**** CONFIDENTIAL ****
Technical Service Bulletin 2018-1047

DATE: November 5, 2018
TO: E-ONE Dealers
FROM: Kevin Kearns, Customer Support Manager
SUBJECT: **Air Restriction Indicator Sensor Wiring, Revision to TSB 2018-1043 dated October 15, 2018**

Fig. 2

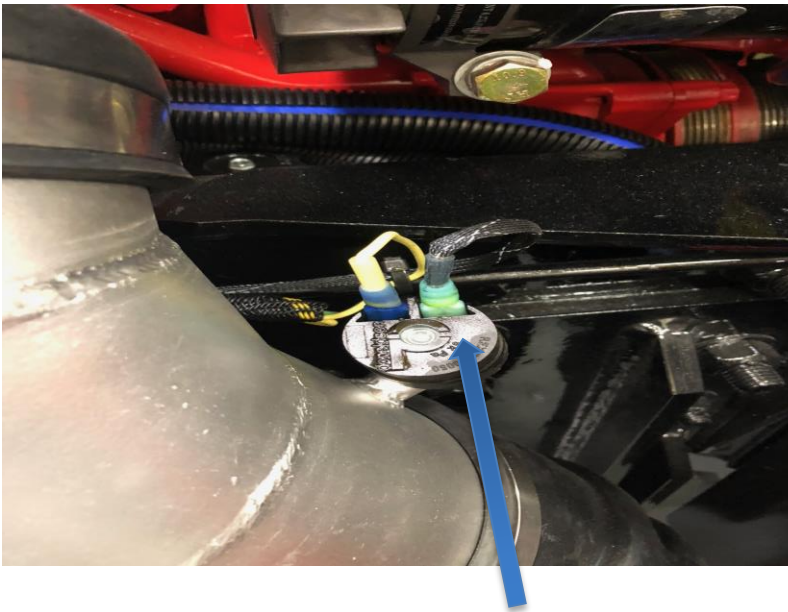
At the right side truck battery ground post, connect a 16 gauge loomed black wire by using a 3/8" insulated ring terminal (see fig 1). Run the loomed wire along side of the cab tilt pull cable from the right side truck battery to the air flow sensor located at the right front air filter elbow. At the air flow sensor, remove the existing "Chassis Ign" (green wire) and seal the end of the circuit. Using a 3/8" insulated female spade terminal (see fig 2) connect the 16 gauge black wire originating at the batteries to the air flow sensor. Secure the loomed 16 gauge black wire to the cab tilt pull cable with wire ties.

In order to allow the gauge cluster air restriction indicator to function correctly, the air flow sensor located at the air filter requires a ground circuit wired from the truck battery to the air flow sensor terminals.
